SECOND FLOOR FRAMING PLAN

△		
△		
△		
△		
△	PLAN CHECK # 1	8/27/07
No.	REVISIONS	DATE

Pfeifer Residence
 3317 Green Mountain Road
 Kalama, WA
 Cowlitz County

Second Floor Framing

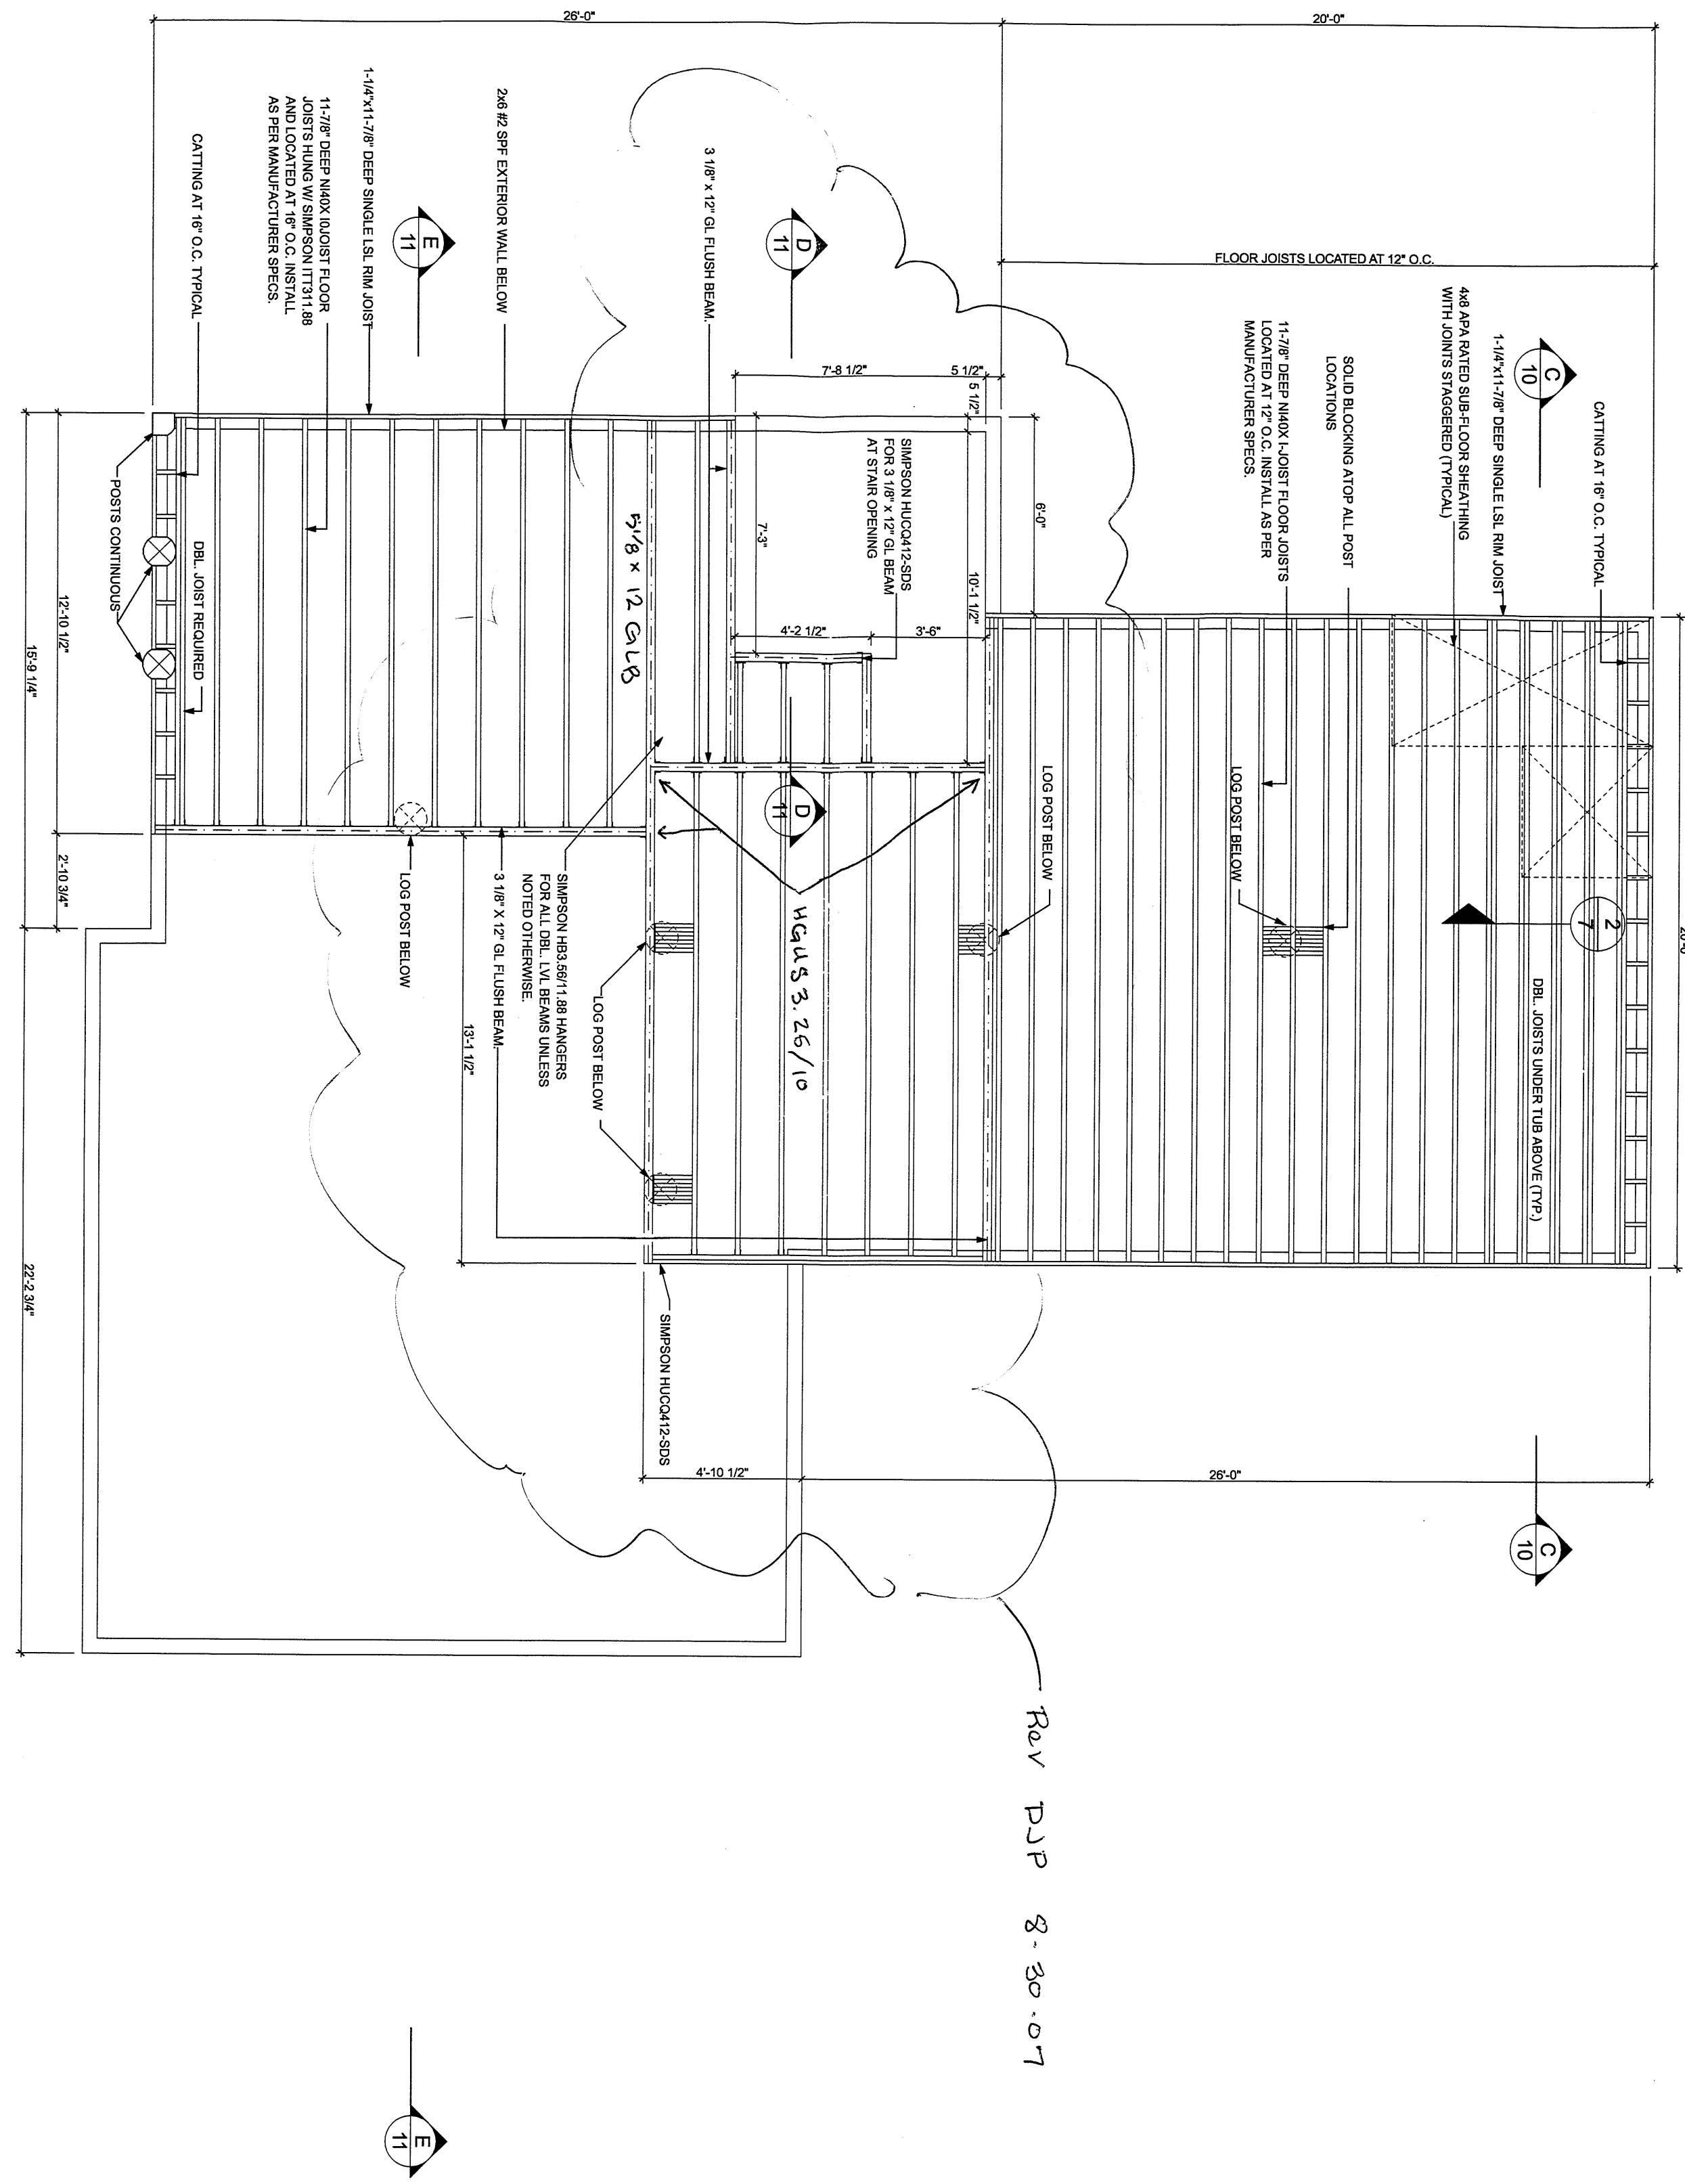
Blocking shall be provided on all floor joists at all intermediate supports.
 Floor and roof trusses to be labeled per an approved third party inspection agency or a professional engineer to be done at time of framing inspection.
